Village of Oxford Planning Commission Agenda
Tuesday, February 7, 2023, 7:00 P.M.
Council Chambers located at:
22 W Burdick Street, Oxford, MI
Tel: 248-628-2543

Subject: **Clean Hub Car Wash – Site Plan Review #3** (Site Plan Dated January 26, 2023)

Regarding: **Clean Hub Car Wash – Site Plan Review #2**
153 S. Washington Street – Parcel ID# 04-27-278-022

RE: 153 S. Washington Street
Second Engineering Plan Review

OXFORD BIKE SHOPPE

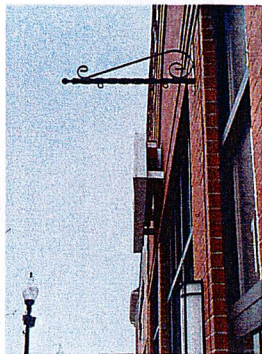
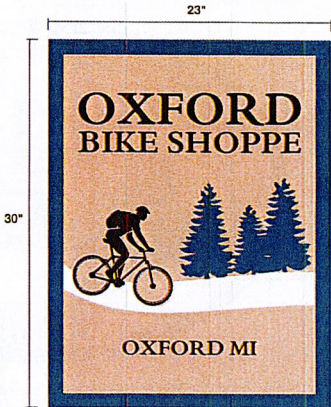
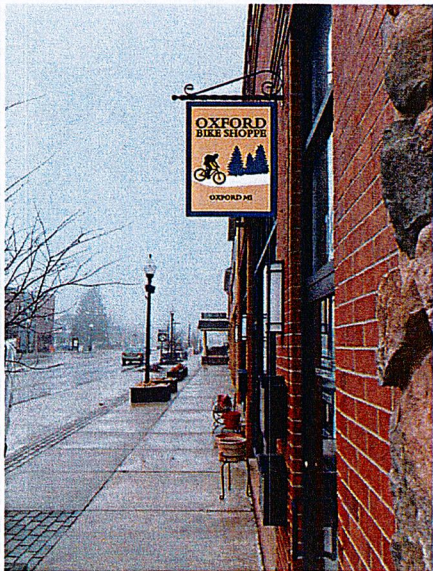
Section 7.4.8(F)(1)(b) requires that internally illuminated signs in the C-1 Core zoning district receive design approval from the Planning Commission. The proposed sign is an aluminum oval with an acrylic face plate that will be internally back-lit by LED light modules. The design is a common style of signage, colloquially referred to as a 'box sign,' that allows for a business to utilize graphics and text in an economical way.

We recommend the Planning Commission grant sign approval for the proposed sign which is in keeping with the general design standards of the Village. Any approval should be contingent upon the installation of a dimmer control module. We recommend the luminance level not exceed 100 cd/m² from dusk to dawn.

ART PLAN DESIGN BUILD	143 S. WASHINGTON STREET CHICAGO, IL 60604
TOPOGRAPHIC SURVEY	143 S. WASHINGTON STREET CHICAGO, IL 60604
CLIENT:	143 S. WASHINGTON STREET CHICAGO, IL 60604

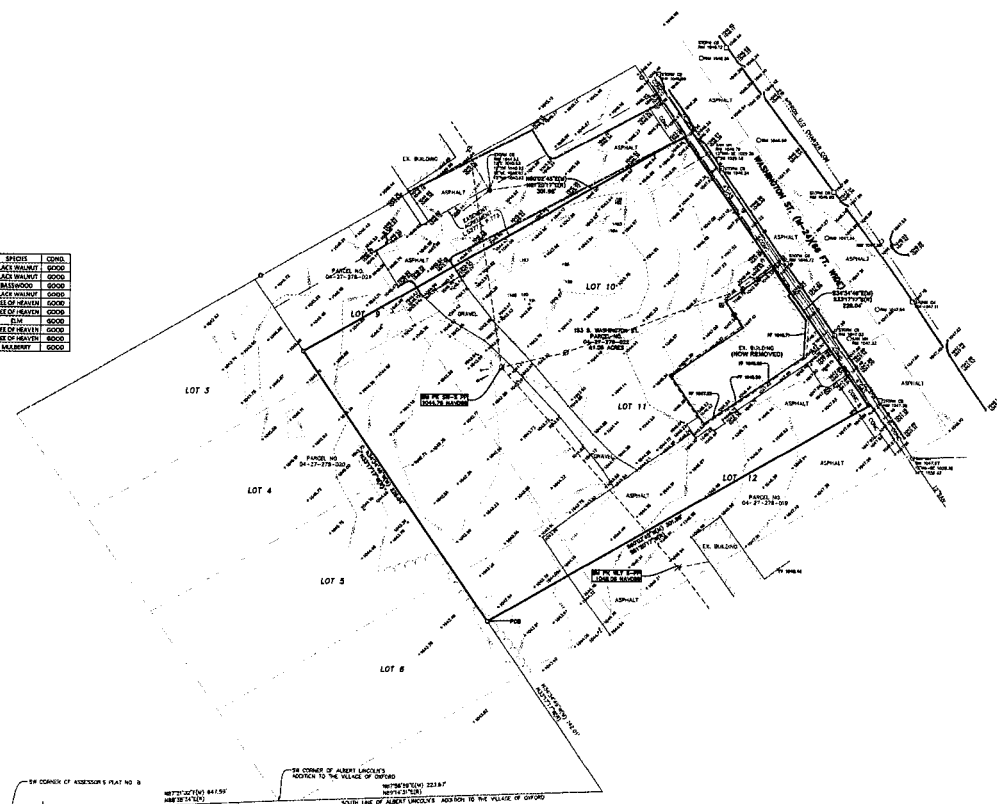
4. Concerning the topographic survey: *"An existing gravel cross access driveway is shown running through the rear, connecting the properties to the north and south..."*
The existing gravel area will not continue in the new design. A title search did not provide any recorded easements regarding this area and will not be sought for in the new design.

1. An existing gravel cross access driveway is shown running through the rear, connecting the properties to the north and south. Also, on the conceptual site plan submitted, there is a reference to an existing easement where this cross-access driveway meets the north property line. However, there is no reference to an easement on the survey. Given the long-term nature of this gravel driveway, it would seem highly possible that there is an easement that bisects the property for the benefit of others. The applicant is asked to verify the existence of the easement. ROWE requests that any easement language that exists be submitted with the next plan revisions for our review, to verify what rights or obligations exist from the easement. If there are no access easements on the property, that should be documented as well. *The survey that was referenced in the first plan review was not included in the revised plan set. It is noted that the new design does not provide any opportunity for cross-access in the area of the existing gravel road that provides access to and from the existing sites to the north and south. Our expressed concerns about the need for additional information regarding existing easements was not addressed.*

2. Similar to the comment above, an existing easement is shown on the site plan along the south property line, but it is not shown on the survey. The existing easement document needs to be submitted for our review, to verify what rights and obligations that it provides. *This item was not addressed. The new traffic configuration that would encourage parked vehicles to back out on to the adjacent easement partly on the neighbor's property makes the submittal of this information vital.*

AS101

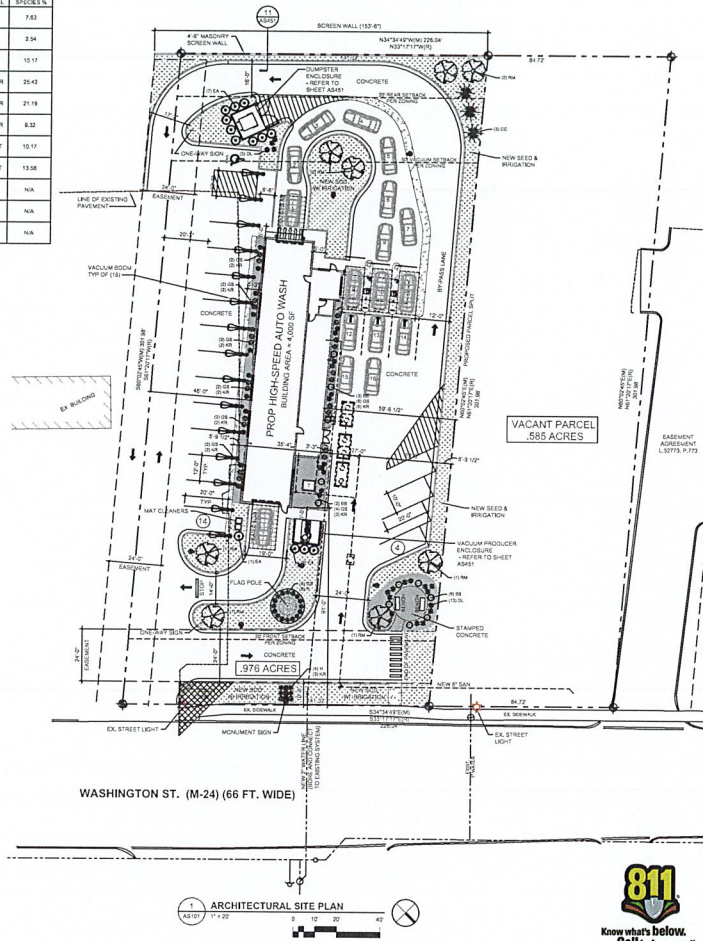
- F. Landscaping.** While atypical, the site plan on Sheet AS101 also includes landscape plan details. It includes the location, species, size and quantity for the proposed landscape materials and generally appears to be in compliance with ordinance standards. However, the Minimum size for deciduous trees at installation is 3.5 caliper-inches diameter and minimum size for evergreen trees is six (6) feet in height. Please revise the height/size columns appropriately for the red maples and the arborvitae to meet this standard.

3. *Minimum size for shrubs at installation is still 36 inches in height or 30 inches in spread. Provided shrubs must be revised to meet this standard.*
The size of the shrubs has been revised – Please see chart on Sheet AS101.

4. *Plant materials shall not include more than 30% of any single plant species. The plant list must be revised to provide the percentage of each planting in a separate column.*
The percentage of the plant species have been added to the landscape chart and are in compliance – Please see Sheet AS101.

5. *The planting schedule still references Macomb County and Shelby Township. The schedule must be revised to reflect Oakland County and the Village of Oxford.*
The text has been revised – Please see chart on Sheet AS101.

AS102

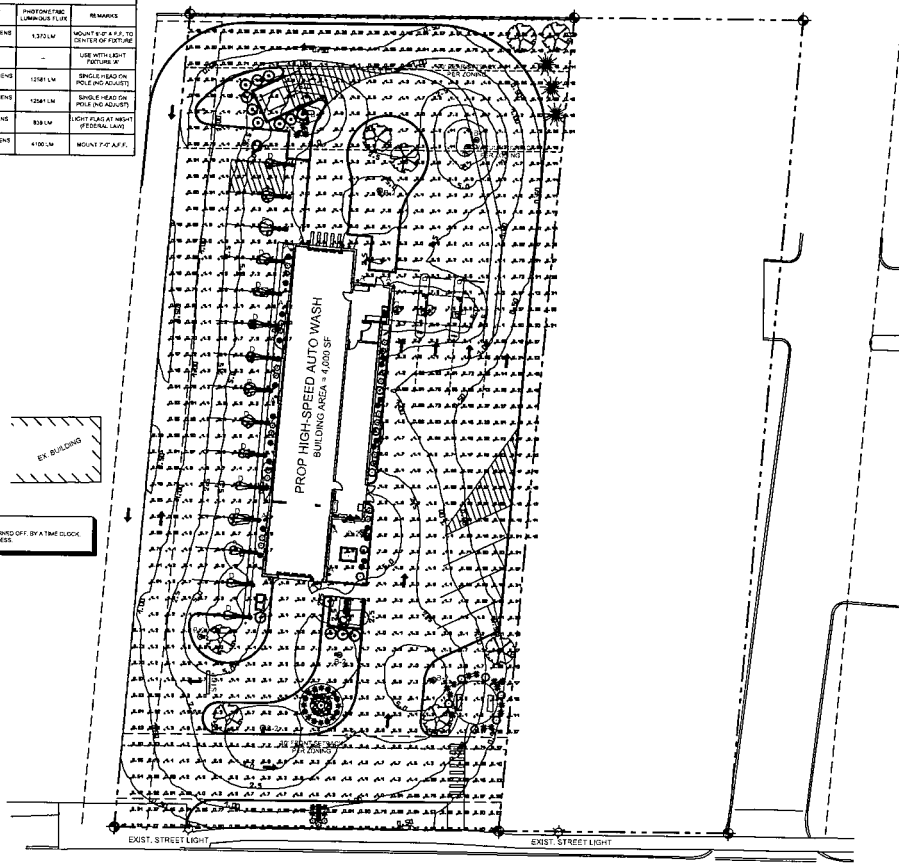
- G. Lighting.** A modified photometric plan has been provided on Sheet AS102. It includes the location of fixtures along with a lighting fixture schedule that includes mounting height. The photometric plan is in compliance with ordinance standards and has addressed previous issues regarding the continuous operation of the vacuum boom lights.

We note that Fixture A is described as an up/down wall sconce. The Planning Commission may approve decorative light fixtures as an alternative to shielded fixtures provided they do not cause off-site glare or light pollution. We would still suggest the use of fixtures that only direct light downward or the use of a different cylinder lens for the uplight that reduces the lumens projected into the sky.

6. *We recommend the “Vacuum Boom” tube light fixtures are turned off when the facility is closed.*
A note has been added to the Site Photometric Plan (AS102) stating that these lights will be turned off by a time clock when the facility is closed.

NOTE:
ALL PARKING LOT POLE LIGHTS ARE TO BE MOUNTED WITH A FIXED ONLY BRACKET AND ALL LIGHTS ARE TO BE FULLY SHIELDED AND POINTED DIRECTLY DOWNWARD

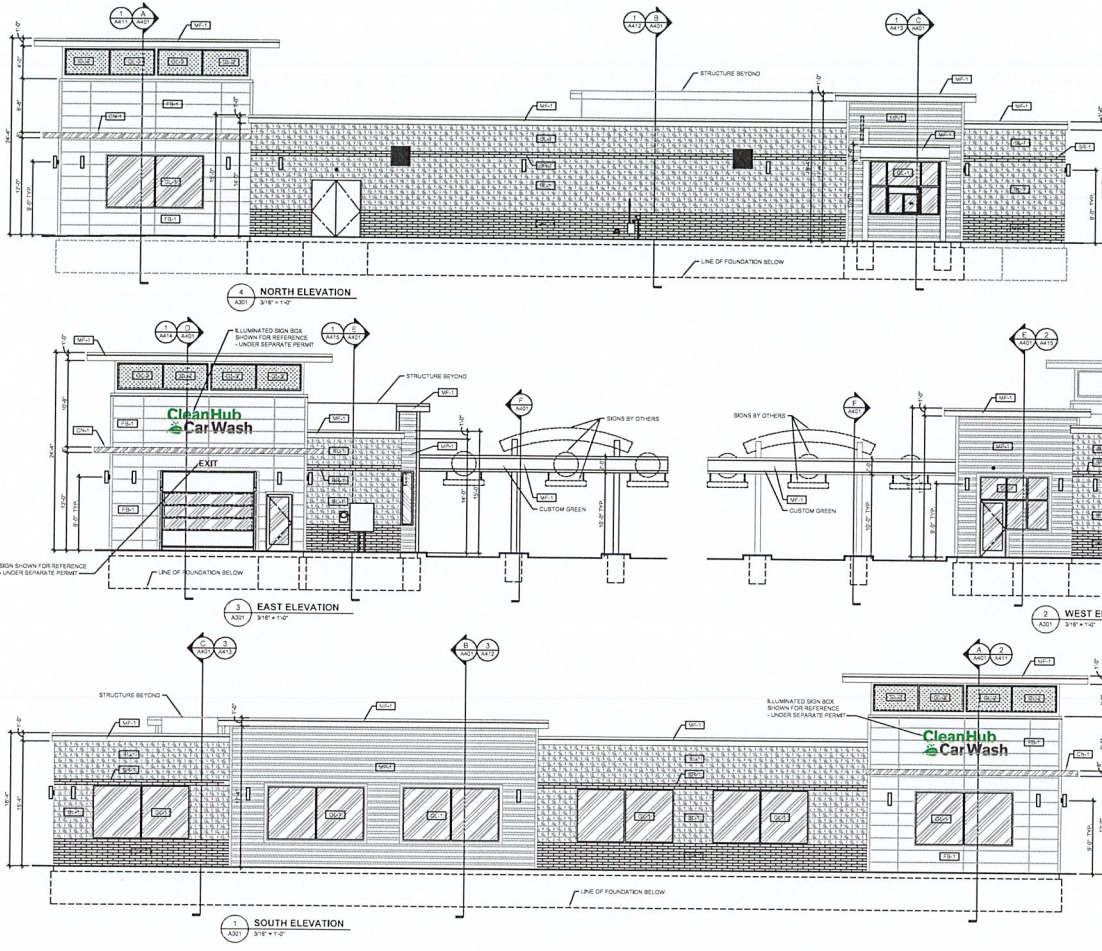
- D. **Building Architecture.** Modified elevations have been provided on Sheet A301. The applicant is proposing to utilize a Jet Black jumbo brick along the foundation of the building with a white split-faced masonry block for the walls. Dark Bronze horizontal metal panels are proposed for the office portion of the building at the northwest corner and along a segment of the south wall. Dark grey fiber cement panels are proposed for the tower feature at the building vehicle exit. Dark colored projected eaves along the cornice line create shadow and add to the overall attractive contrast between light and dark surfaces. While there are minor modifications to window placement and the proposed office, the same design aesthetic is utilized, and the building is still modern and attractive for the proposed use.
